Item ID: D206-781-041

Item Name: Baggage Compartment Protector Wall

DART SERVICE INSTRUCTION

TO AMEND INSTALLATION INSTRUCTIONS IIN-D407-781-2 REV. A OR LATER APPROVED REVISION
AND INSTRUCTIONS FOR CONTINUED AIRWORTHINESS ICA-D407-781 REV. 3 OR LATER REVISION

**FIGURE 1 - D3879-1 BAGGAGE COMPARTMENT WALL
PROTECTOR - ALTERNATE INSTALLATION**

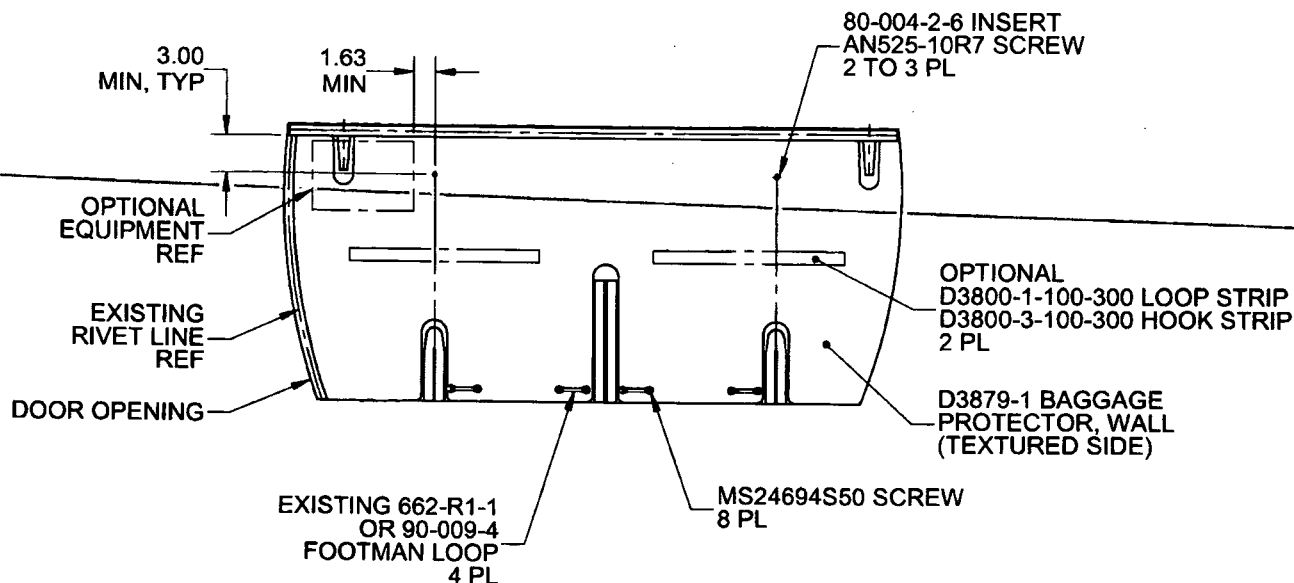
In some aircraft, the top portion of the D206-781-041 Baggage Compartment Wall Protector Kit cannot be installed as indicated in IIN-D407-781-2. The purpose of this DSI is to provide an alternate mounting method to fasten the top portion of the D206-781-041 Baggage Compartment Wall Protector Kit.

It is acceptable to replace qty(2) D3930-1 Clips with qty(2) 80-004-2-6 Inserts. Locate and mark location of the two attachment holes on the baggage compartment wall as shown in Figure 1 of this service instruction. Install 80-004-2-6 Inserts at the marked locations in accordance with Section 3-2-12 of BHT-206-SRM-1. It is acceptable to trim the wall protectors to accommodate optional equipment or transfer attachment holes to the wall protector and install the optional equipment on top of the wall protector with longer fasteners.

Amend the D206-781-041 Baggage Compartment Wall Protector Kit parts list as follows:

Qty -061	Qty -031	Qty -041	Part Number	Description
X			D206-781-061	BAGGAGE COMPARTMENT PROTECTOR KIT (FLOOR AND WALL)
1	X		D206-781-031	BAGGAGE COMPARTMENT FLOOR PROTECTOR KIT
1		X	D206-781-041	BAGGAGE COMPARTMENT WALL PROTECTOR KIT
		2	AN525-10R7	SCREW
		2	80-004-2-6	INSERT
